MEMORANDUM

Community Development Department
 City of Royal Oak, Michigan

SUBJECT: Conditional Rezoning from One Family Residential and Neighborhood Business to Mixed Use 2 and associated Site Plan (SP 16-07-18) to redevelop site of former religious institution and off-street parking lot into 28 townhouse multiple-family dwelling units in 7 buildings at 3506 Rochester Rd. (parcel nos. 25-03-377-030 & 25-03-378-001)
 Robertson Brothers Homes, Petitioner
 First United Methodist Church of Royal Oak, Owner
 Nowak & Fraus, PLLC, Engineer / Alexander V. Bogaerts & Associates, PC, Architect

SHEET
Emergency Vehicle
Access Plan

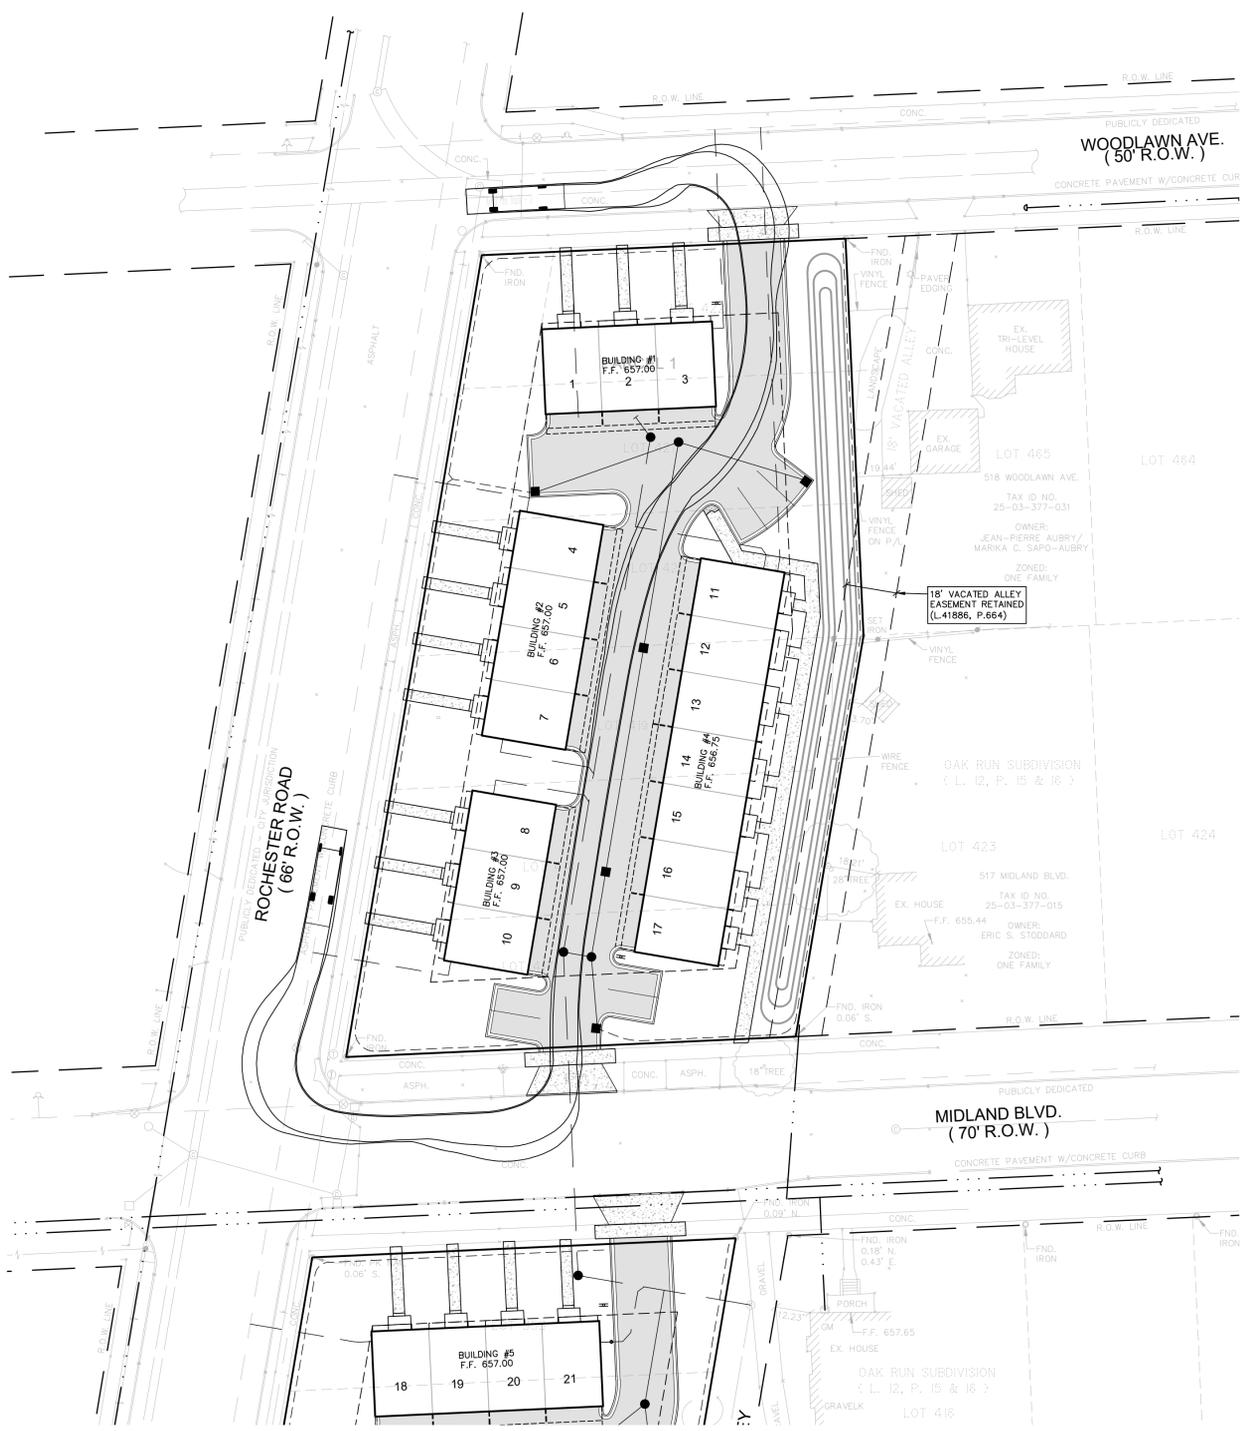
- F. Emergency Access. The second-level balconies above the garage doors may present an issue for emergency vehicles. The façade elevations indicate the bottoms of the balconies are between eight feet and 11 feet above the pavement. According to the Fire Marshall a minimum height of 13 feet 6 inches is required where the balconies project above maneuvering aisles and garage entrances. The balconies may need to be modified accordingly to comply with the required standards of the Fire Code.

- (1) The species and calipers of existing trees to remain along and within the public alley adjacent to parcel 25-03-378-001 shall be identified;
 - (2) Balconies shall have a minimum clearance to grade as required by the Fire Marshall; and

■ sheet title:
Overall Landscape Plan

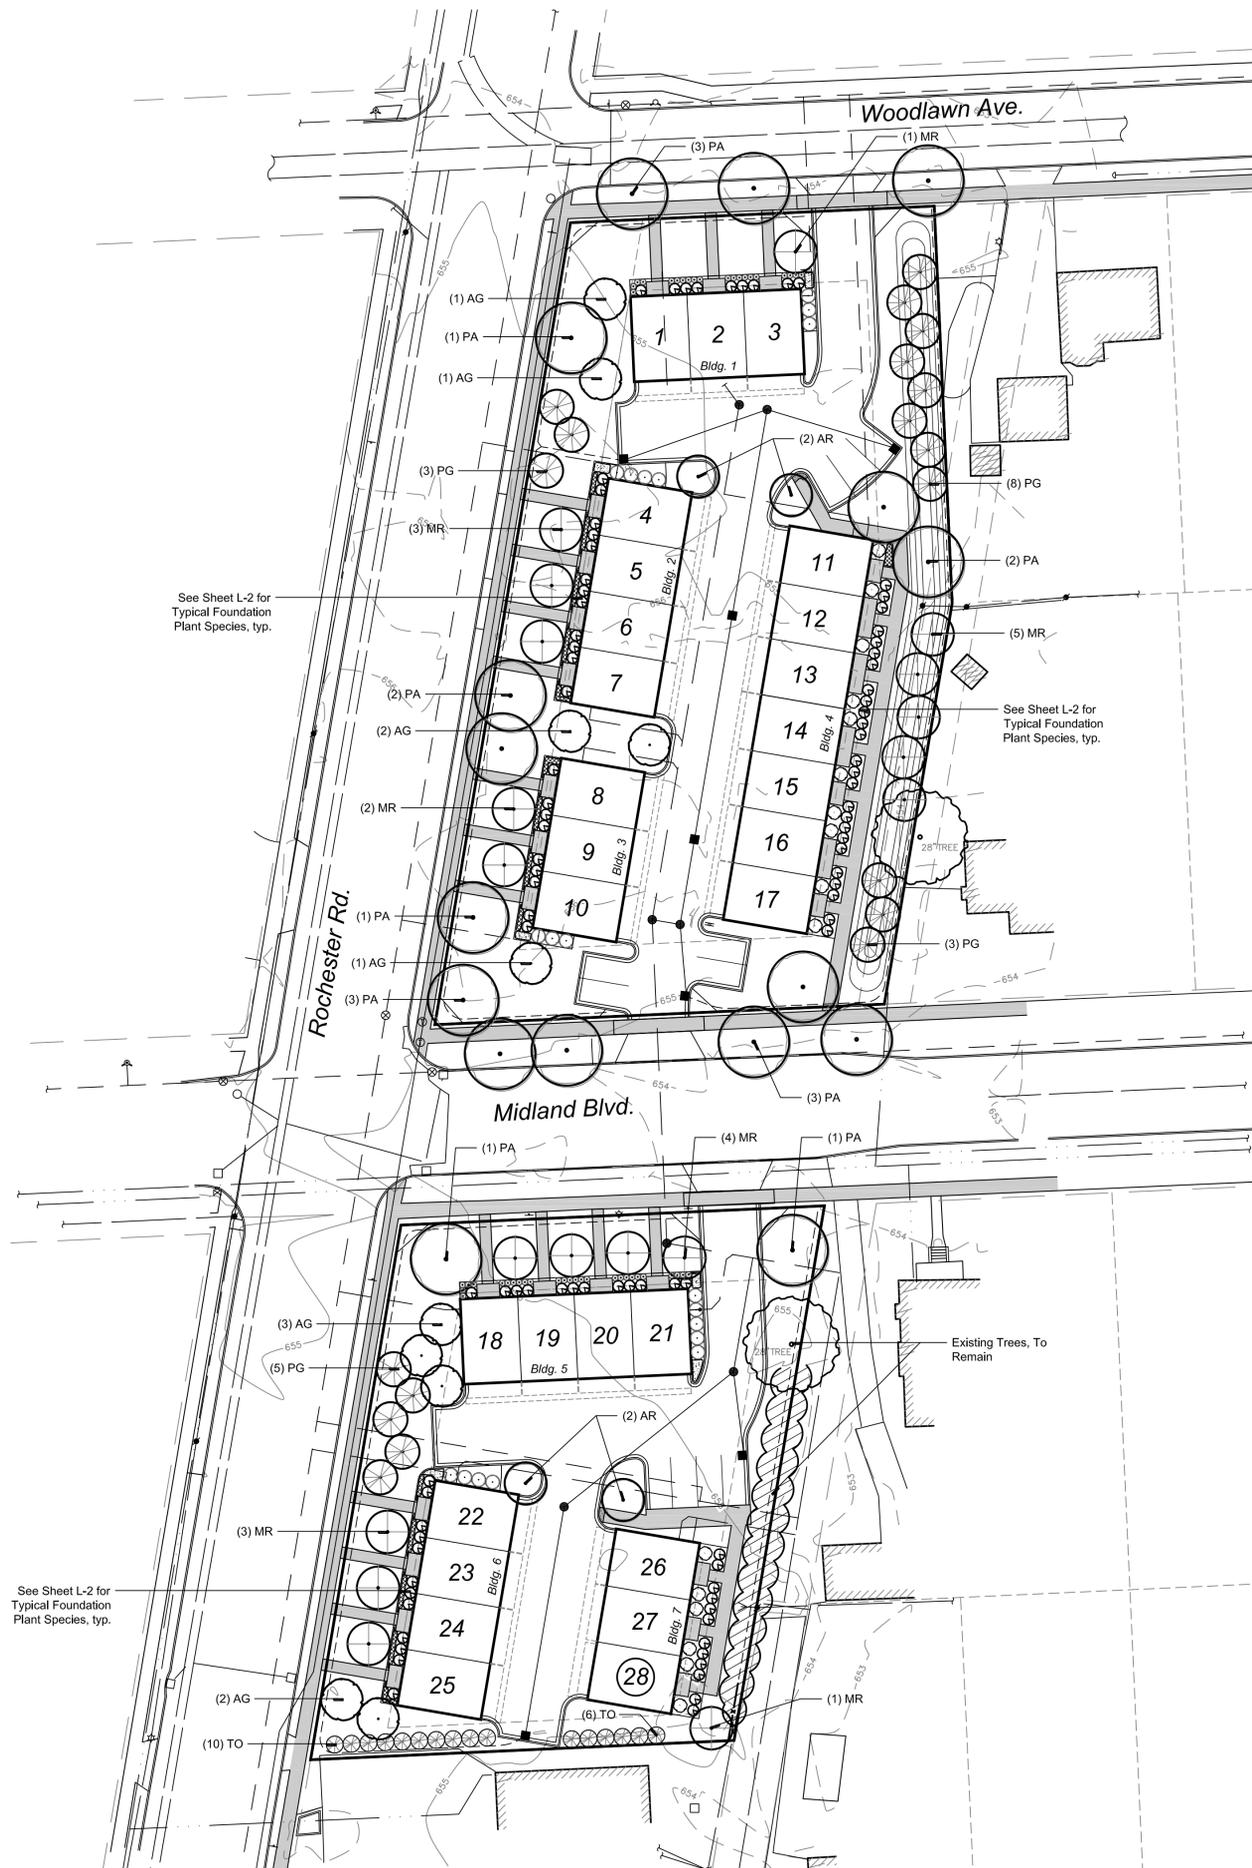
- G. Landscaping & Screening. Screening is required along the east rear lot lines of each parcel in accordance with § 770-90 (D) due to the adjacent One Family Residential zoning of properties to the east. A landscaped buffer with a combination of evergreens, deciduous trees, earthen berms, or masonry walls may be required under this subparagraph at the discretion of the Planning Commission.

Staff recommended a landscaped greenbelt along the east rear lot lines of each parcel in 2015. Suggested plantings were a mixture of 6-foot evergreens and 2.5-inch caliper deciduous trees planted at 20 feet of center in a staggered pattern. This latest landscaping plan proposes a greenbelt along the east rear lot line of the church lot with eight deciduous trees having calipers of two to three inches and 11 evergreen trees with a height of six feet.

Only two new deciduous trees are proposed on the parking lot parcel along the public alley; however, the landscaping plan notes that several existing mature trees will remain. Staff recommended that these trees be kept as part of the previous applications since they provide excellent screening for the single-family neighborhood to the east. The species and calipers of these existing trees should be identified on the landscaping plan, however.

The site plan also includes front yard greenbelts along Rochester Road, Midland Boulevard, and Woodlawn Avenue, with deciduous trees in front of each unit and evergreens between parking areas and the right-of-way. Street trees are also provided along Woodlawn Avenue and Midland Boulevard. Street trees within the Rochester Road right-of-way are not provided due to the lack of space between the sidewalks and curbs according to the petitioner.
